RE: ***Final***
Response to United States Environmental Protection Agency (EPA) E-Mail Comments Dated April 10, 2008 on Interim Measures Work Plan (IMWP) for Solid Waste Management Unit (SWMU) 13 (Mine Fill B)
Naval Surface Warfare Center (NSWC) Crane
Crane, Indiana

RESPONSE TO COMMENTS (RTCs) DATED APRIL 10, 2008
FROM UNITED STATES ENVIRONMENTAL PROTECTION AGENCY (EPA)
(E-MAIL FROM PETER RAMANAUSKAS)
ON THE INTERIM MEASURES WORK PLAN (IMWP) RTCs DATED DECEMBER 20, 2007
FOR SWMU 13 – MINE FILL B
NAVAL SURFACE WARFARE CENTER
CRANE, INDIANA

DRAWING NO. FIGURE 3 - 1

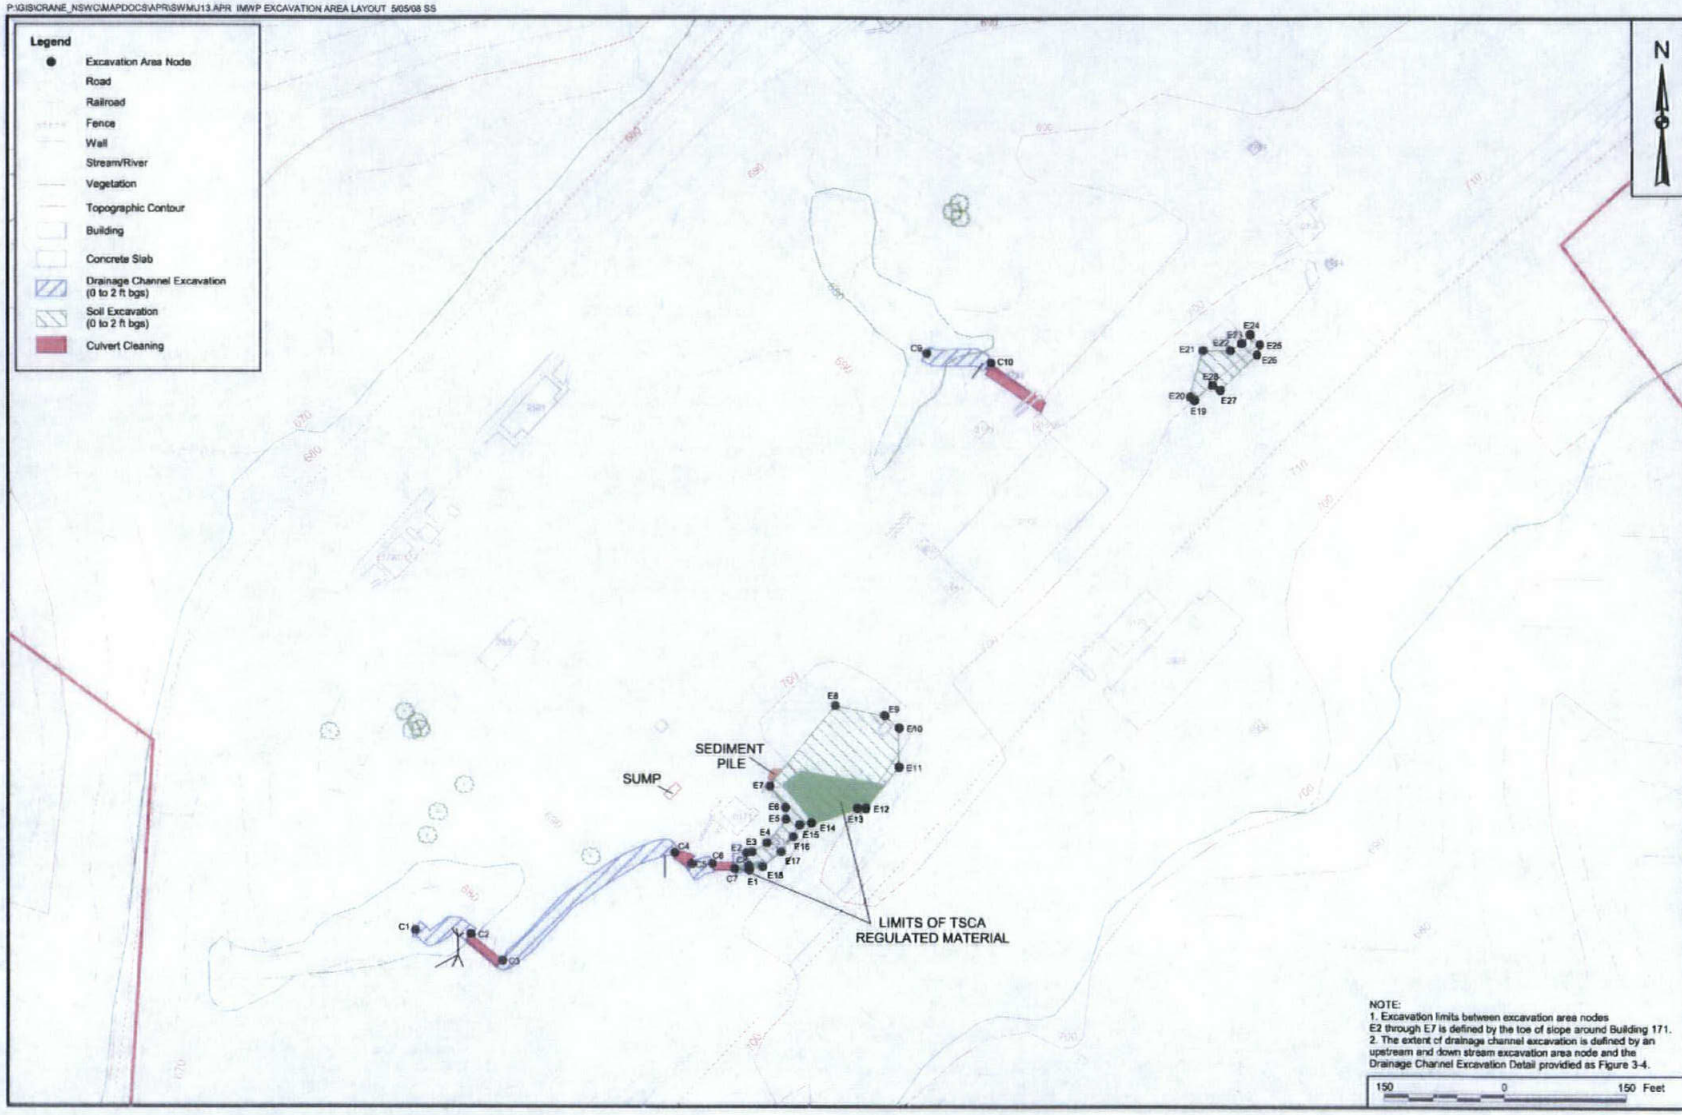
EPA-1 (4-10-08) regarding Response to EPA-1b & 1c:
Response 1c does not address the comment. Overall, the text remains confusing with respect to which buildings were known to have PCB use and which buildings are having PCB contaminated soil removed. For example, Section 3 describes work around B-169 and B-171 but does not talk about B-166 while Figure 3-1 shows work proposed around B-166. Some places in the text discuss B-166/171 and others B-169/171. Please describe work taking place at all three buildings and what the sources of PCB were at each building. If a building did not have a source of PCB, describe how PCB came to be located near the building.

EPA-5c (4-10-08): Sediments must be tested for PCB concentration for disposal characterization prior to any consolidation. > 50 ppm and < 50 ppm materials should be kept segregated.

Response to EPA-1 (4-10-08): Figures 3-1, 3-2, and 3-3 indicate a fenced area northeast of Building 169 with "0166." This area is a fenced in area where the former Building 166 Therminol Boilers were located. The Therminol Boilers for Building 166 and Building 171 are believed to be the sources of polychlorinated biphenyl (PCB) contamination at SWMU 13 (Mind Fill B). PCB activities did not occur at Building 169. The purpose of referencing Building 169 is as a landmark for the remediation Environmental Multi Award Contractor (EMAC). The Navy believes that it is appropriate to use Building 169 as a landmark because of its location relative to the proposed remediation areas.

For clarification, Figure 3-1, 3-2, and 3-3 (See Attachment 1) have been modified to include a legend for the former foundation pad of the Therminol Boilers rather than fenced areas. Additionally, these figures have been modified to show Building 166.

Based on the available analytical data, 6 sample locations contain total-PCBs at concentrations that exceed 50 mg/kg. Figures 3-1, 3-2, and 3-3 have been revised to indicate the locations of the soils that must be stockpiled separately for disposal at a TSCA regulated landfill. Additionally, the text and volume tables have been updated to indicate the inclusion of material to be disposed at a TSCA regulated landfill. Additional sampling for disposal will be performed based upon requirements of the selected landfill.

DRAWN BY MF	DATE 4/7/08	DRAINAGE CHANNEL EXCAVATION DETAIL SWMU 13 - MINE FILL B INTERIM MEASURES WORK PLAN NSWC CRANE CRANE, INDIANA	CONTRACT NO. 0352
CHECKED BY	DATE		OWNER NO. 0020
REVISED BY	DATE		APPROVED BY / DATE
SCALE NOT TO SCALE			DRAWING NO. FIGURE 3-4 / REV. 0

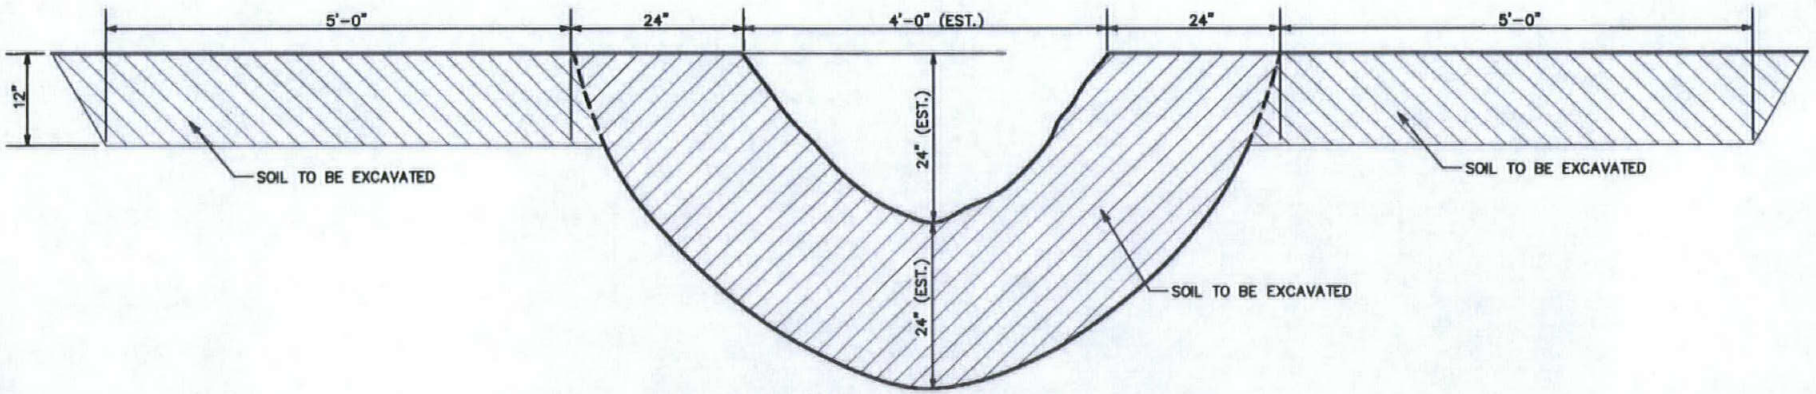
EPA-6 (4-10-08) regarding Response to EPA-16:
The Navy must take confirmation floor samples. The configuration of the drainage channel or excavation does not eliminate the requirement for confirmation sampling. Please propose a confirmation floor sampling plan.

Response to EPA-6(4-10-08): The excavation shape related to the drainage channel excavation is an irregular shape (see Figure 3-4 in Attachment 2). As a result of the irregular shape, verification samples will be collected from the exposed exaction floor of the channel overflow areas located on each side of the "V / U" shaped channel. Within the "V / U" shaped channel one verification sample will be collected from each of the exposed surface defining the sides of this "V / U" shaped excavation. To illustrate the locations of verification sample collection, a new figure (Figure 5-1 see Attachment 3) has been added to the text and is provide as part of this response to comment document.

- For the channel excavation area of the drainage trenches, every 100 foot of excavation length. These excavations are approximately 6 foot by 100 foot (see Figure 3-4) (e.g., 1 composite sampler per 600 square foot).

- For the channel-overflow excavation area of the drainage trenches, every 100 foot of excavation length. These excavations are approximately 5 foot by 100 foot (see Figure 3-4) (e.g., 1 composite sampler per 500 square foot).

- *"Drainage Channel Excavation Areas - Verification samples will be collected from the excavation sidewalls and floors. Due to the irregular shape of the drainage channel excavation (see Figure 3-4), two verification samples will be collected from the exposed overflow floor areas located on each side of the channel (i.e., from the channel overflow areas) and two verification samples will be collected form the exposed surfaces of the drainage channel (Figure 5-1). Verification samples will be composite samples as described in the QAPP (TtNUS, 2006). These four composite samples make up one set of verification samples. At a minimum, one set of verification samples will be collected from each drainage channel segment and for every 100 linear feet of drainage channel excavation. In the event that a drainage pipe is encountered during the drainage channel excavation process, the frequency of verification sample collection will be increased to one set of verification samples for every 25 linear feet of drainage channel excavation. Therefore, based on the proposed length of drainage channel excavation within 100 feet downstream of the piping outlet areas, if drainage pipes are not encountered, seven sets*
